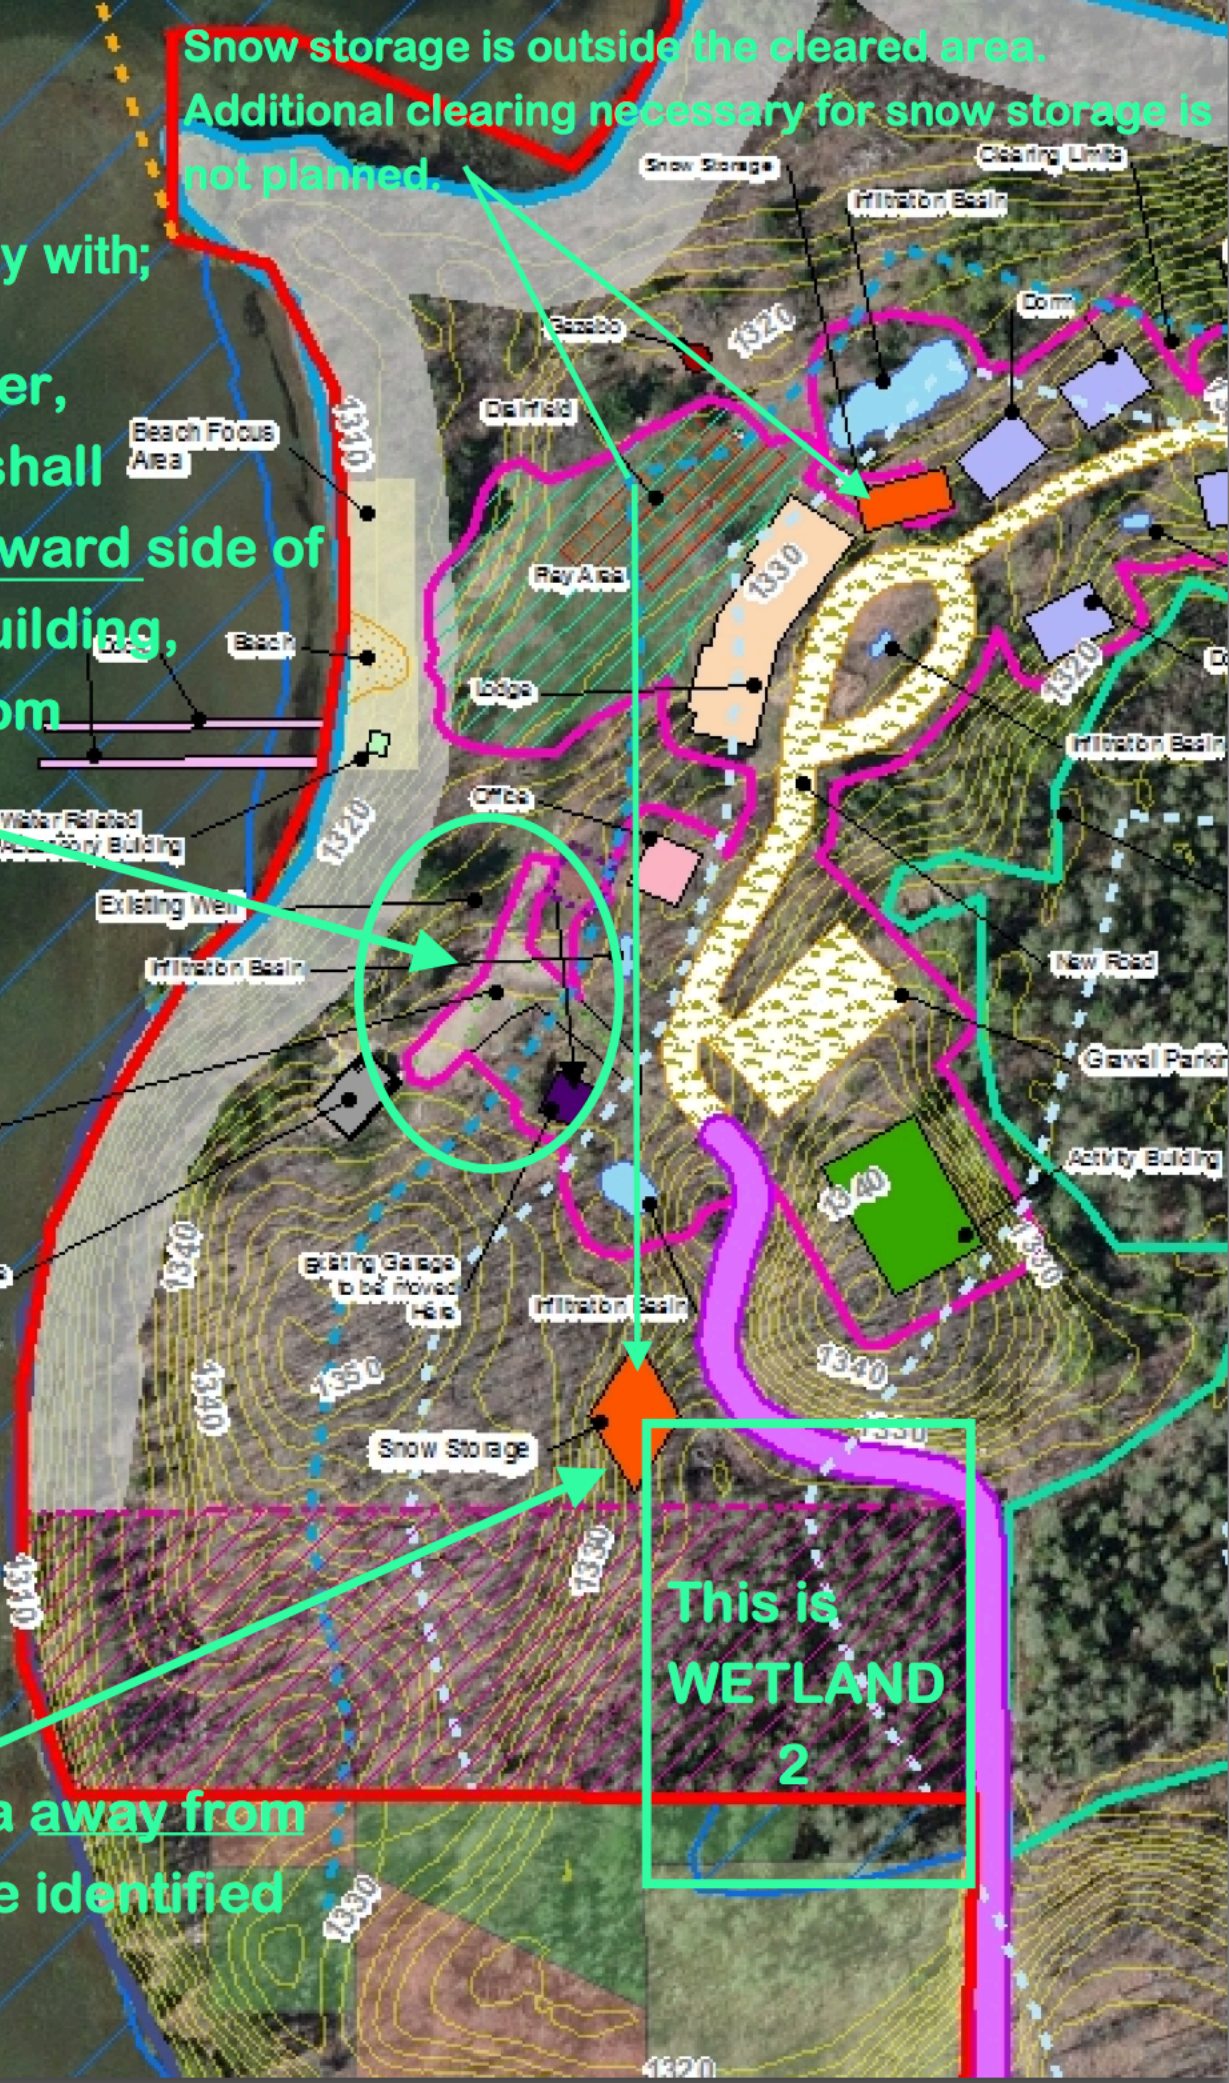
Snow storage is outside the cleared area.
Additional clearing necessary for snow storage is not planned.

The Plan does not comply with;
CUP Resolution & Order,
22. all parking areas shall
be located on the landward side of
the lodge and office building,
and shall be hidden from
view of the lake.

The incomplete
site plan does
not include
WETLAND 2.

CUP Resolution &
Order, # 30 requires
"A snow stockpile area away from
the wetland will also be identified
on the final plan."

This is
WETLAND
2
